# PARK CITY MUNICIPAL CORPORATION PLANNING COMMISSION

September 14, 2016

Treasure Hill Conditional Use Permit, Creole Gulch and Town Lift Mid-station Sites – Sweeney Properties Master Plan <i>Review of proposed density and public hearing</i> <i>Consideration of Motion to Continue Public Hearing to October 12, 2016</i>	PL-08-00370 <i>Planner</i> <i>Astorga</i>	79
--	---	----

158 Ridge Avenue – Steep Slope Conditional Use Permit for a new Single Family Dwelling. <i>Public hearing and possible action</i>	PL-16-03149 <i>Planner</i> <i>Hawley</i>	143
--	--	-----

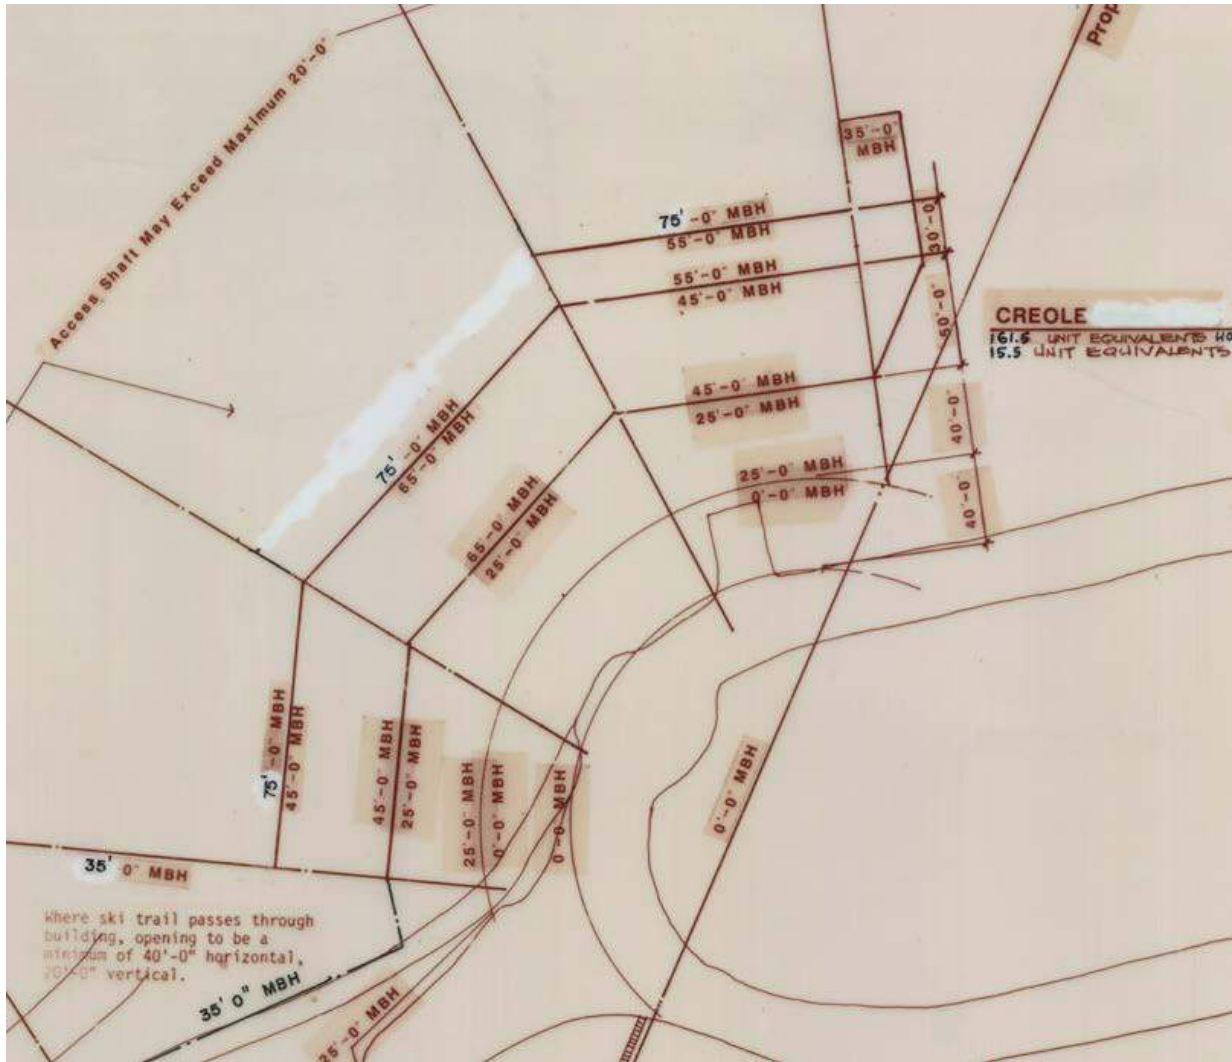
*The 1986 MPD approval set standards for increased density and increased height on the site. The MPD set height envelopes over the site which increased the allowed height from the front to the rear lot lines. The area closest to the front lot line along the Lowell Avenue/Empire Avenue switchback was set at a 0' maximum building height. The maximum building height increases in steps from the front property line. Maximum elevations were also set within the MPD. The mid-station maximum elevation was set at 7420 feet and 7275 feet for Creole. The current application complies with the height requirements set forth in the MPD, yet the design modifies existing grade well beyond the anticipated amounts shown in the exhibits of the MPD.*

*The following is a portion of the Creole Height diagram from the MPD exhibits page 22.*

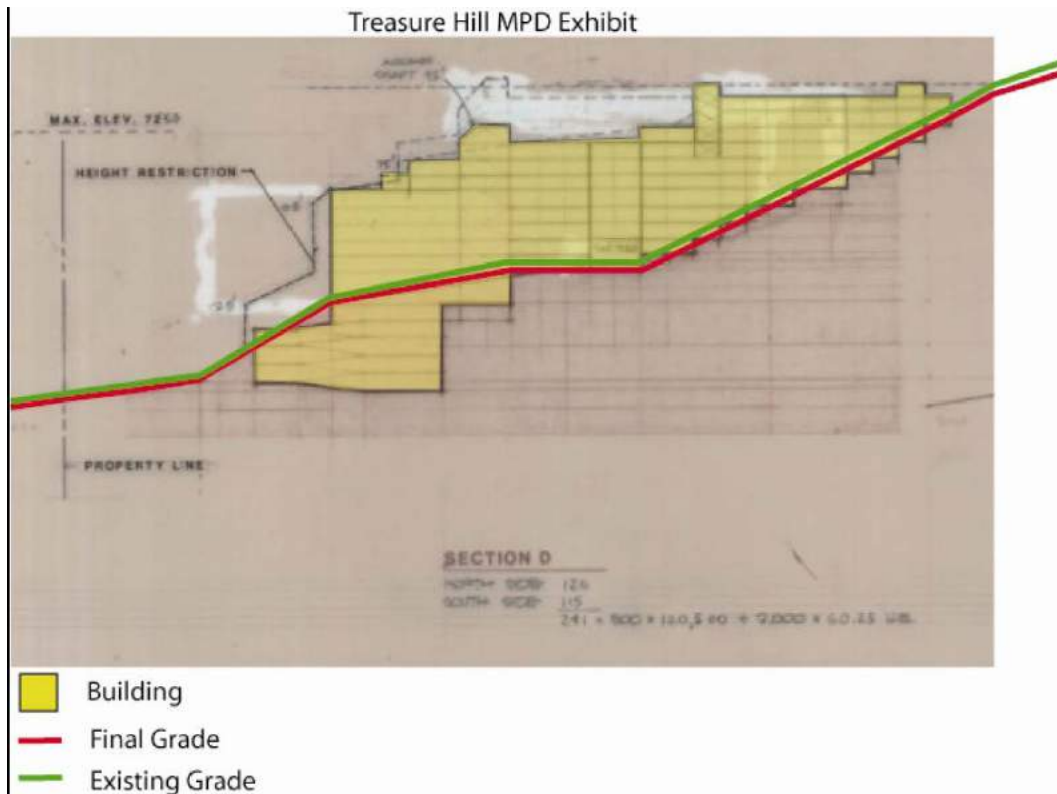
*This MPD exhibits designated the areas that the buildings could be built within the development parcel. The second guiding document is the conditions of approval for the MPD in which maximum height envelopes were defined. The following is from the findings within the MPD approval.*

*Staff finds that the excess square footage included in the project that is influencing the building massing and bulk. The building mass and bulk is also influencing the orientation of the buildings on the site. The original MPD exhibits were to be utilized as guiding documents. The following is from Exhibit 19 and is an architectural section of one of the buildings on the Creole site.*

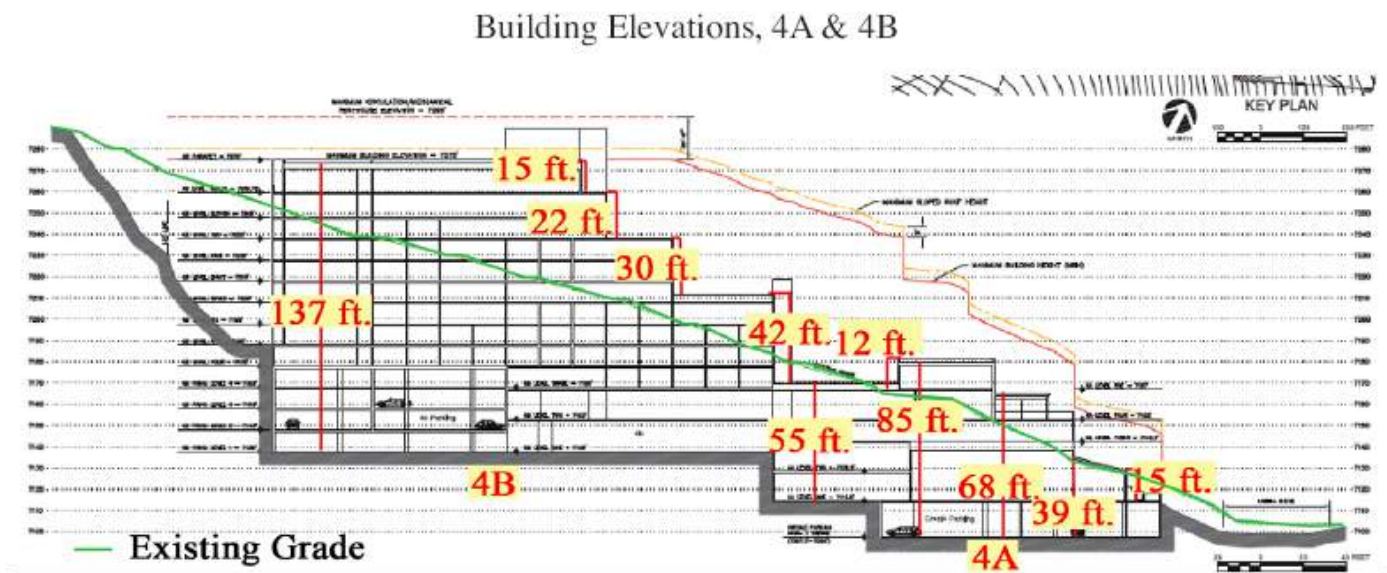
The building steps with the grade on the site and manages to keep final grade (after construction) close to existing grade (pre-construction). The majority of the area shown below grade is for the parking.

The current application places more massing and bulk below the existing grade. Not only is the massing placed below the existing grade, the grade is then altered dramatically creating taller building walls, taller retaining walls, and greater massing. The following is a section through Creole site plan of the project. The green line is existing grade. The red line is the maximum height envelope. By creating a lower final grade, the buildings appear taller and the bulk and massing becomes larger. The pedestrian walking through the project will experience higher building walls due to the change in final grade. Also, the view from other parts of town (Exhibit B) is of building with greater massing due to the change in final grade from existing.

Staff expects grade to be altered on the unique, steep site in order to accommodate the amount of density allowed on this site, exterior circulation, and parking. The extent to which existing grade is being altered is far beyond the anticipated amount within the MPD and is creating greater impacts to mass and scale. The MPD was clear that the height measurement would occur from natural grade and were within height envelopes. By modifying natural grade over 100 feet, the height envelopes do not serve the purpose for which they were created.

Criteria 15. Within and adjoining the site impacts on environmentally sensitive lands, slope retention, and appropriateness of the proposed structure to the topography of the site.

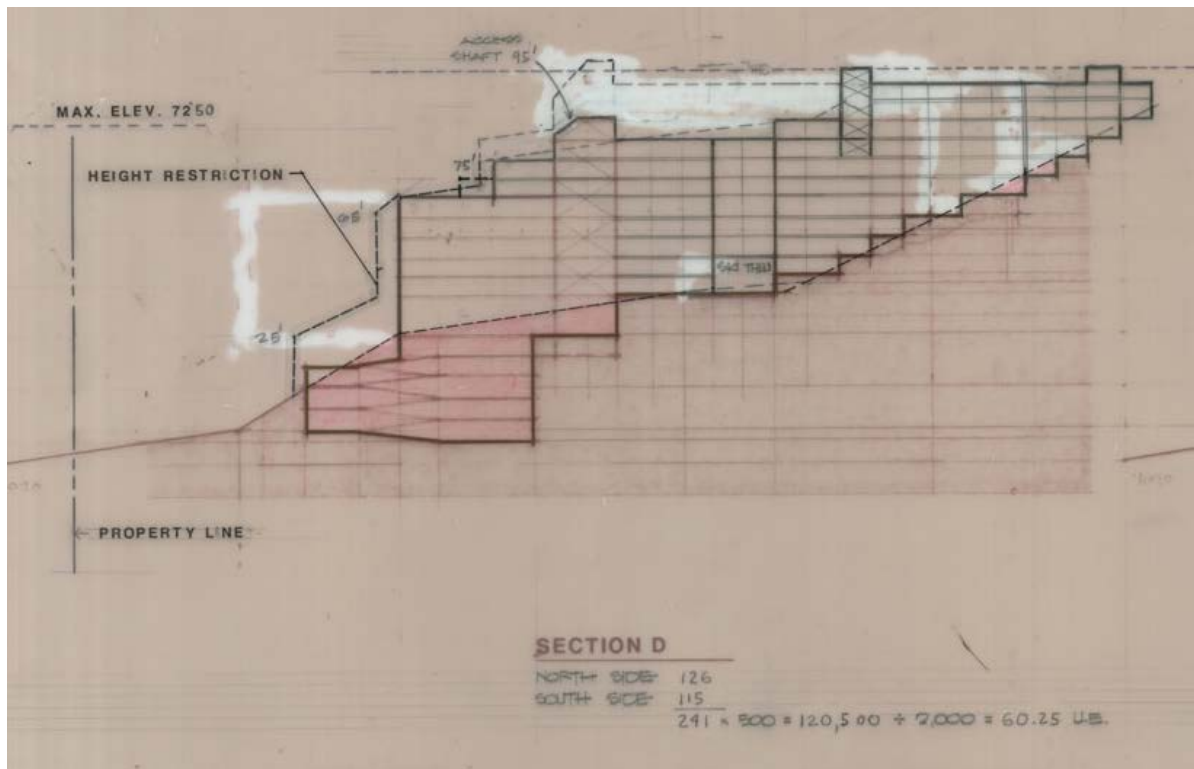
*The proposed design requires a very large excavation and re-grading of the entire site. The project is located on the mountain side on steep topography. The impacts to the slope and existing topography are substantial and unmitigated. The project as designed will create a very large hole on the site. The project does not step with the natural topography of the site. As discussed previously, staff finds the project as designed is not in compliance with the concept approved by the City Council during the 1986 Master Plan approval. The exhibits within the master plan showed the building volumes stepping with the existing grade with the exception on the underground garage.*

*By stepping with the natural grade, there is less excavation. The exhibits within the master plan are guiding documents. The exhibits show minimal impacts on excavation.*
